<b>DEVELOPMENT NO.:</b>	22034970
<b>APPLICANT:</b>	Carlisle Developments Pty Ltd
<b>AGENDA ITEM NO:</b>	3.4
<b>ADDRESS:</b>	76 South Terrace, Adelaide SA 5000
<b>NATURE OF DEVELOPMENT:</b>	Construct twelve level mixed use building comprising offices at ground and level one, dwellings on levels 2 to 12 and rooftop terrace
<b>ZONING INFORMATION:</b>	<b>Zones:</b> <ul style="list-style-type: none"> <li>• Capital City</li> </ul> <b>Subzones:</b> <ul style="list-style-type: none"> <li>• City Frame</li> </ul> <b>Overlays:</b> <ul style="list-style-type: none"> <li>• Airport Building Heights (Regulated)</li> <li>• Affordable Housing</li> <li>• Building Near Airfields</li> <li>• Design</li> <li>• Hazards (Flooding - Evidence Required)</li> <li>• Noise and Air Emissions</li> <li>• Prescribed Wells Area</li> <li>• Regulated and Significant Tree</li> </ul> <b>Technical Numeric Variations (TNVs):</b> <ul style="list-style-type: none"> <li>• Maximum Building Height (36 metres)</li> <li>• Minimum Building Height (4 levels)</li> </ul>

<b>LODGEMENT DATE:</b>	18 October 2022
<b>RELEVANT AUTHORITY:</b>	City of Adelaide Council Assessment Panel
<b>PLANNING &amp; DESIGN CODE VERSION:</b>	2022.19 – 13

**Figure 9.2 – Allotments and built form established and developed as part of DA/980/2002 DA/1020/2003**

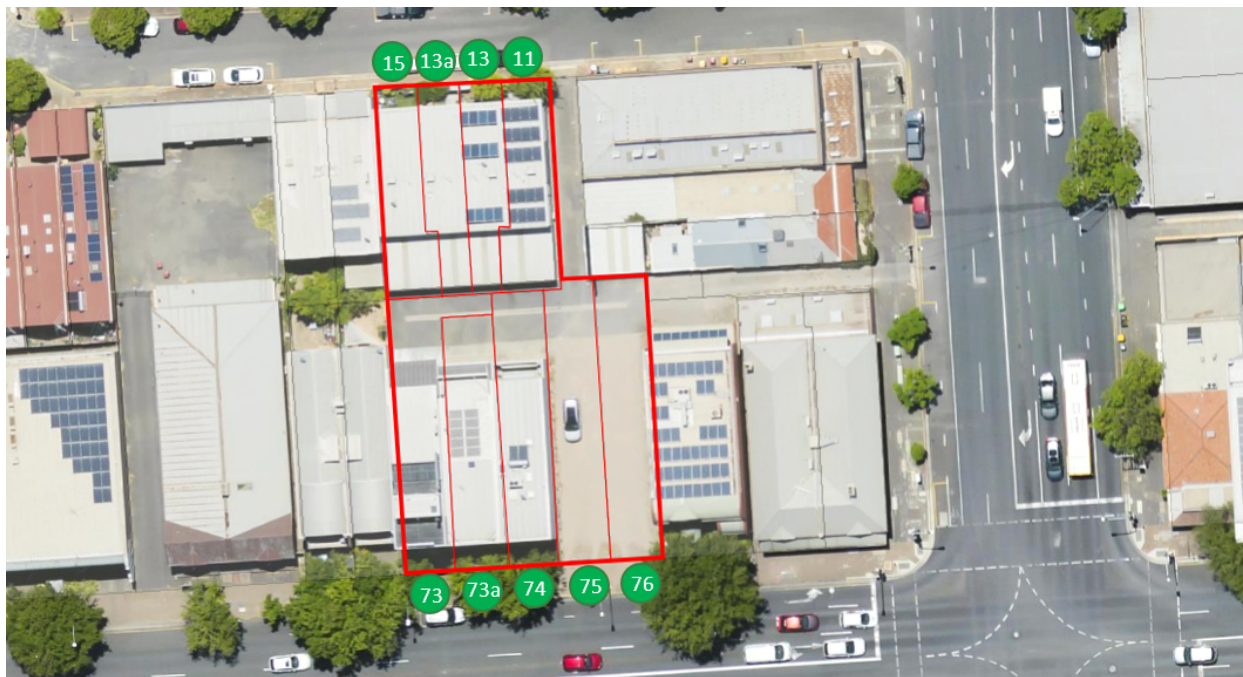
Allotments of similar width to the subject site in the locality have more proportionate heights, ranging from one to three levels. As detailed in Section 2 of this report, the site once formed part of larger parcel of land, with a built form and land division approved which informed the immediate context in Figure 9.2. Sites at 17 and 19 Halls Place and 71 and 72 South Terrace have similar proportions, however they were developed separately to those in Figure 9.2.

A significant degree of deviation from the prevailing context is proposed in terms of scale and the proposal is considered at variance at Zone PO 3.1 and PO 5.1, despite ‘framing’ the city street.

**Figure 9.3 – Ground floor elevation highlighting neighbouring datum heights in red**

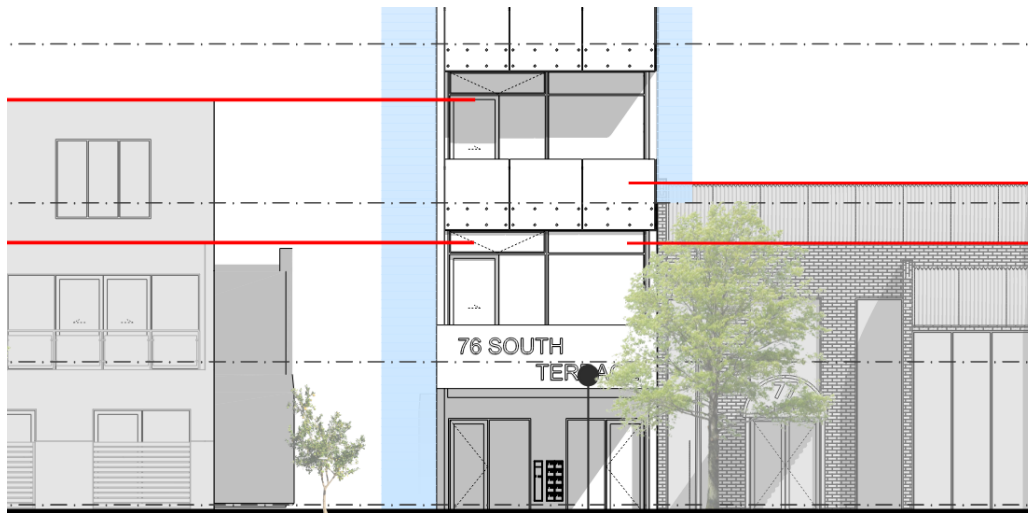
There are several key design elements expected to result in a poor urban design outcome, specifically relating to street presentation. The established built form and character adjacent the site is mixed in terms of height and form. Figure 9.3 illustrates the varied and established datum heights of adjacent low and medium rise developments, which are not incorporated into the architectural expression of the proposal. Consequently, the building will not reinforce prevailing datum heights and parapet levels on South Terrace expressed in Zone PO 3.2.

**Figure 9.4 – Architectural render of buildings lower levels looking north east**

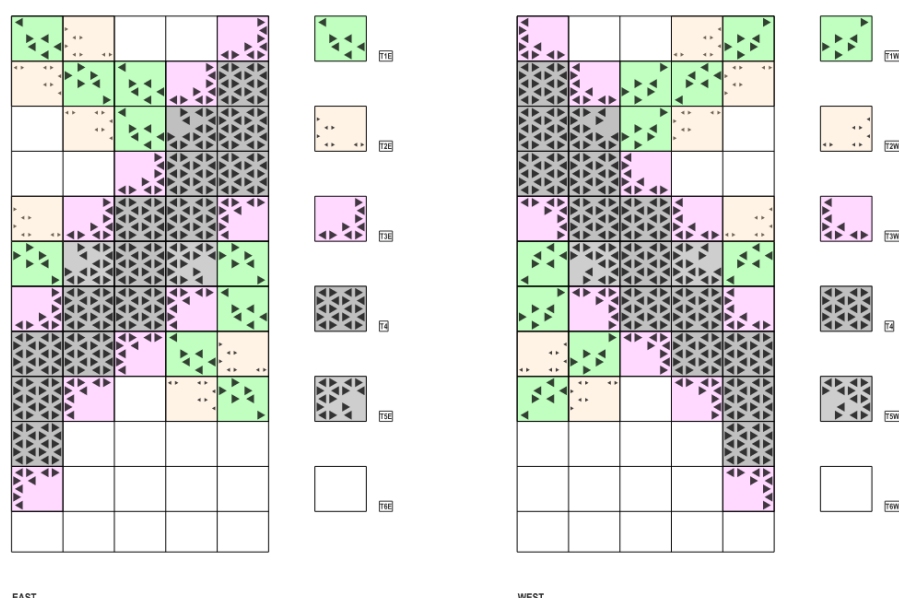
The proposal also includes a ground floor setback from South Terrace. Prevailing setbacks in the locality are mixed and therefore lack of conformity to adjacent setbacks is not fatal. A further shallow 1.1 metre setback is incorporated from levels 2 to 12, utilising this setback for balconies. However, the visual relief and beginnings of a podium are lost as the building incorporates a full height vertical element limiting outlook and passive surveillance to the west. This element is highlighted in red in Figure 9.4.

The façade treatment exhibits an appropriate degree of modelling through minor changes in setback and protruding balconies, however this is impacted by the western vertical element.

**Figure 9.6 – Schematic diagram of light access to apartments**

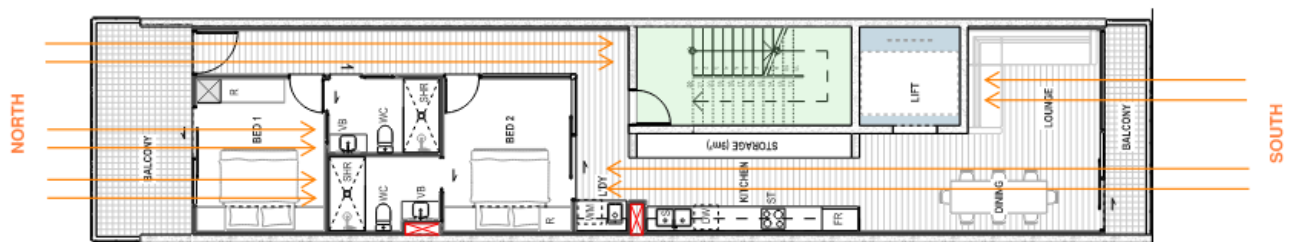
Despite the functional and amenity achievements detailed above, the built form and internal layout exhibit shortcomings, largely due to the narrowness of the site. The 5.6 metre width presents limited opportunity to adapt a functional internal floor plan whilst optimising internal amenity.

Bed 1 will have a high quality outlook, with a large expanse of glazing oriented north unlike Bed 2 which will have no direct access to sunlight. The design seeks to replace two bedroom walls with 'switch glass,' which enables switching between a clear window panel and a non-transparent opaque panel. Whilst an innovative approach, Figure 9.6 demonstrates the intent to rely on borrowed light for 50% of the bedrooms departs from Design in Urban Areas PO 18.1.

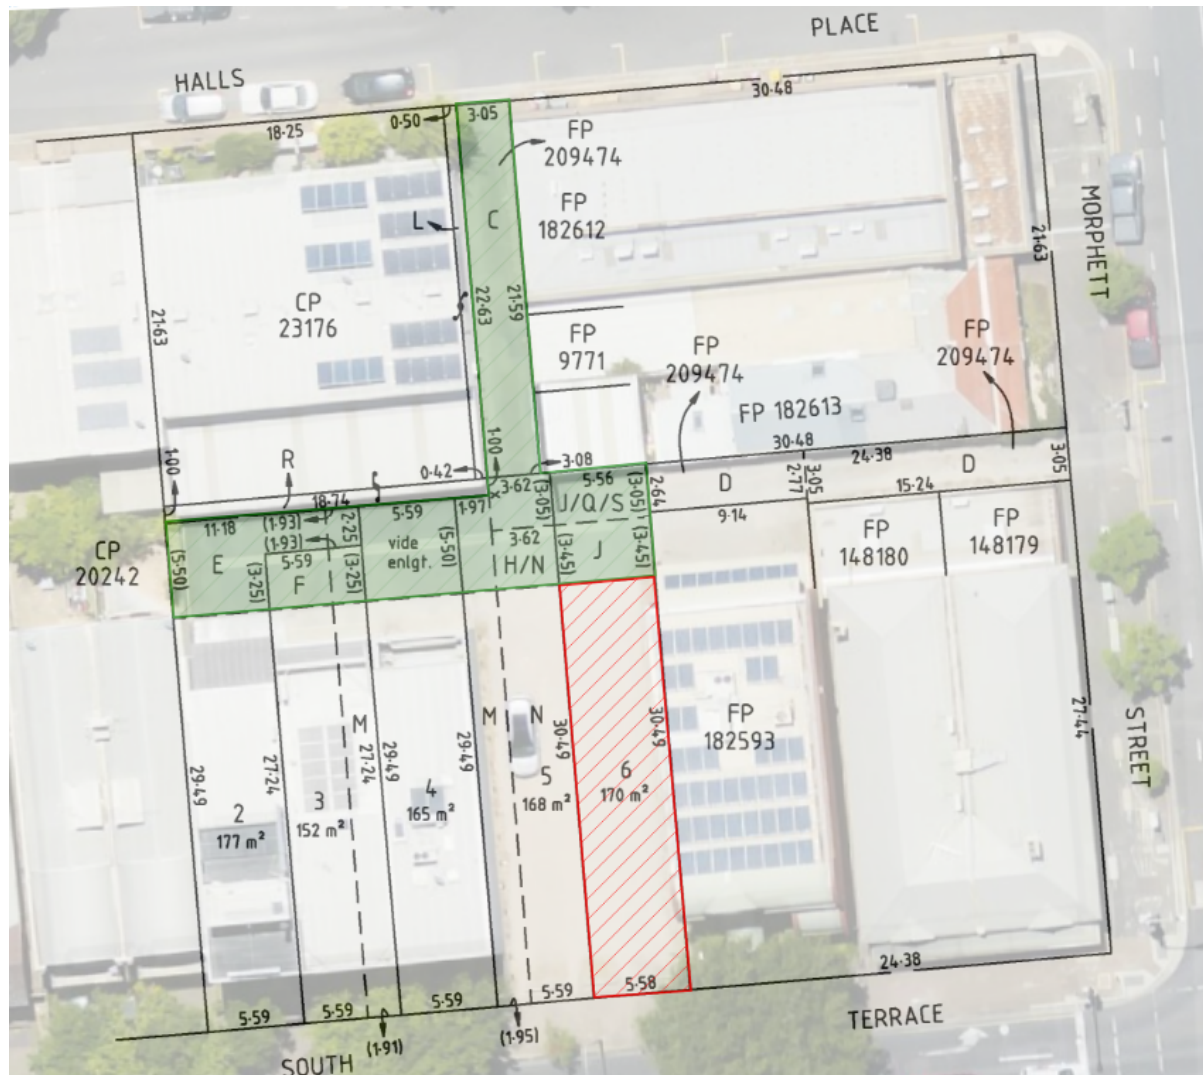
Figure 9.8 details areas where the site has rights of way highlighted in green, with the subject site highlighted in red. According to Certificate of Title Volume 5956 Folio 773, the site is subject to the following:

- The site does not have rights of way over the land marked D to Morphet Street.

Representors have raised concerns regarding the lack of a 2 metre setback from the land marked J, as building setbacks were encouraged as part of the previous built form approvals to ensure sufficient manoeuvrability for vehicles into and out of garaging areas.

The proposal includes a modest setback of 800mm from the land marked J, however as the proposal does not include on site access or parking, a further setback is not required.

The applicant has advised that waste collection via a smaller collection vehicle is intended to utilise the RoW. However, specific details regarding proposed ingress and egress of waste vehicles have not been provided.
